SUNDRY NOTICES AND REPORTS ON WELLS

OH RANDEL #7

Plug and Abandon Procedure

CONDITIONS OF APPROVAL

Proposed P&A Diagram

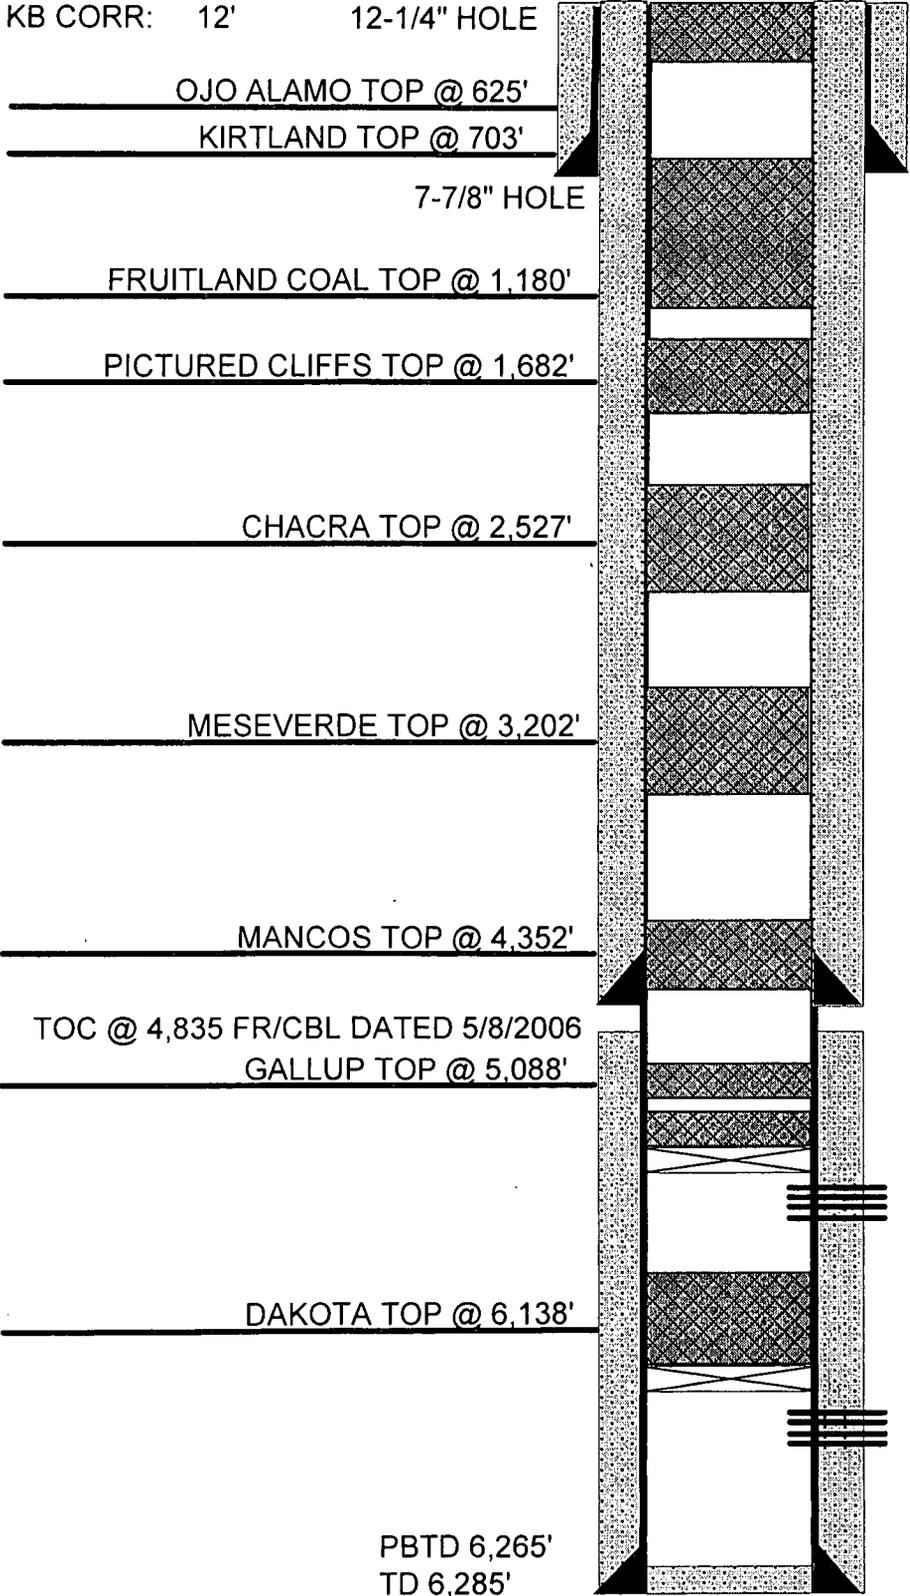
- a) Place the Mancos plug from 4420'- 4320'.
- b) Place the Mesavered (La Ventana) plug from 2589'- 2489'.
- c) Place the Chacra plug from 2127'- 2027'.
- d) Place the Pictured Cliffs plug from 1704'- 1604'.
- e) Place the Fruitland plug from 1464'- 1364'.
- f) Place the 8 5/8" Casing Shoe/Kirtland/Ojo Alamo plug from 888'- 538'.

You are also required to place cement excesses per 4.2 and 4.4 of the attached General Requirements.
